Department of
Community Development

TO: Cherry Hill Township Planning Board Members
FROM: Cosmas P. Diamantis, Esq., Director
 Mara Wuebker, PP, AICP, Deputy Director
 Jacob Richman, PP, AICP, Senior Planner
 Samuel Opal, Planning & Zoning Assistant
RE: **PLANNING BOARD REVIEW**
Devel, LLC
(Centura Development)
Browning Lane
Cherry Hill, New Jersey 08003
Block 433.20 Lot(s) 15.01&16.01(formerly Lot 1)
Application No. 17-P-0001 (Phase 1 & 2)
Application No. 18-P-0002 (Phase 3)
DATE: October 6, 2022

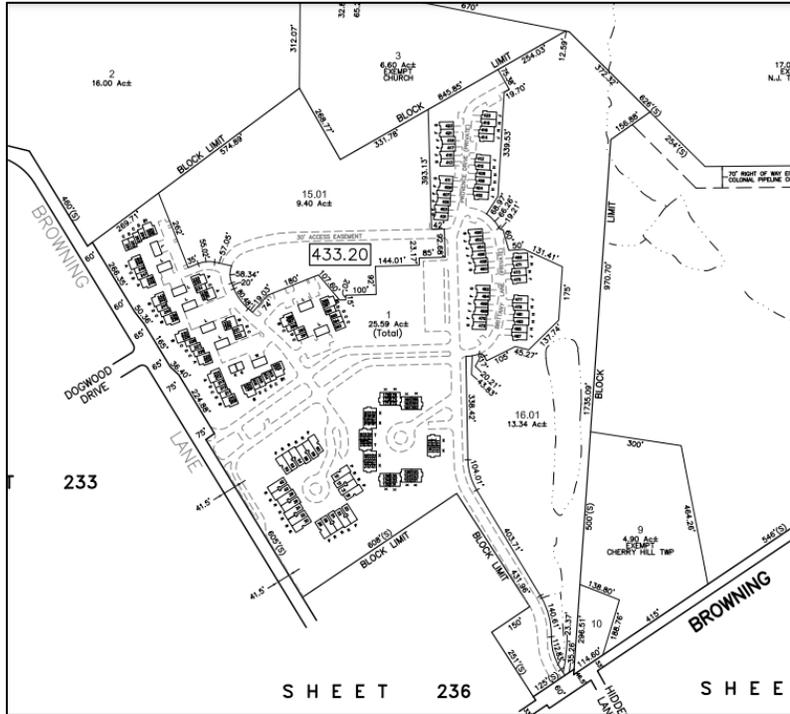
45. *Tax Map. Each block and each lot shall be numbered, as approved by the Tax Assessor. Prior to the filing of any Master Deed, all new lot numbers, qualifiers and addresses shall be assigned by the Cherry Hill Tax Assessor (whom has confirmed the designation of Lots 15.01 and 16.01). Please note that the changing the lot numbers will affect current and future homeowners, which should be reflected in amended master deeds. The Tax Map provided on the plans shall*

be updated to include the updated tax map which reflect the recent delineations of Lots 1, 15.01 and 16.01 (see Tax Map Sheet 234 – excerpt included).
